Access Compliance Report Public Rights-of-Way (Curb Ramps)

Main Street: COLERIDGE_DR Cross Street: FOSTER_RD Location: N

ADA ID: RPAT211202125524 Ramp Type: Type 1 - Perpendicular Diagonal Initial Pass/Fail: Fail Overall Compliance: No Severity Score: 15

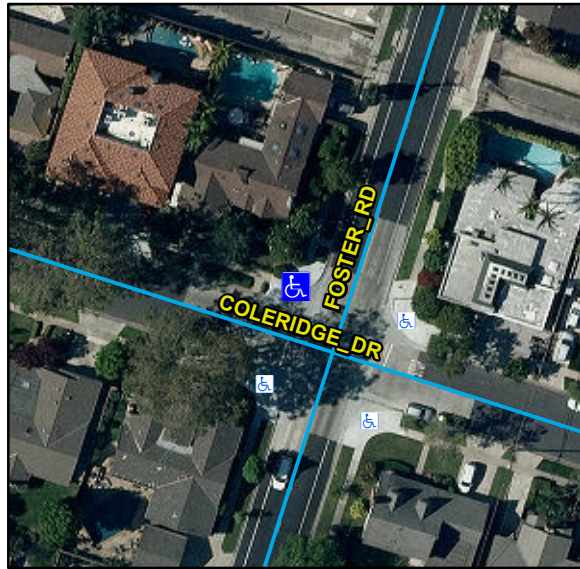
Compliance	Description	Data	Compliance	Description	Data
N/A	Ramp Length (in)	83	N/A	Flare Type LT	
Yes	Ramp Width (in)	48			N/A
No	Ramp Run Slope (%)	8.6	N/A	Flare Slope LT (%)	N/A
Yes	Ramp Cross Slope (%)	1	N/A	Flare Traversable LT	N/A
N/A	Landing Present	N/A	N/A	Flare Type RT	
N/A	Landing Length (in)	N/A			N/A
N/A	Landing Width (in)	N/A	N/A	Flare Slope RT (%)	N/A
N/A	Landing Run Slope (%)	N/A	N/A	Flare Traversable RT	N/A
N/A	Landing Cross Slope (%)	N/A	N/A	DWS Provided	N/A
N/A	Landing Movement Obstructed?	N/A	N/A	DWS Contrast	N/A
	Landing Movement Type	N/A	N/A	DWS Length (in)	N/A
N/A	Landing Shared	N/A	N/A	DWS Full Width	N/A
N/A	Clear Space	Yes	N/A	DWS Offset Left (in)	N/A
N/A	Clear Space To Crosswalk (in)	N/A	N/A	DWS Offset Right (in)	N/A
N/A	Marked Crosswalk 1	No	N/A	Marked Crosswalk 2	No
	Crossing 1 Direction	SW		Crossing 2 Direction	SE
	Marked Crosswalk 1 Width (in)	N/A		Marked Crosswalk 2 Width (in)	N/A

Remove & Replace Curb Ramp With Two New Directional Ramps or Equivalent.
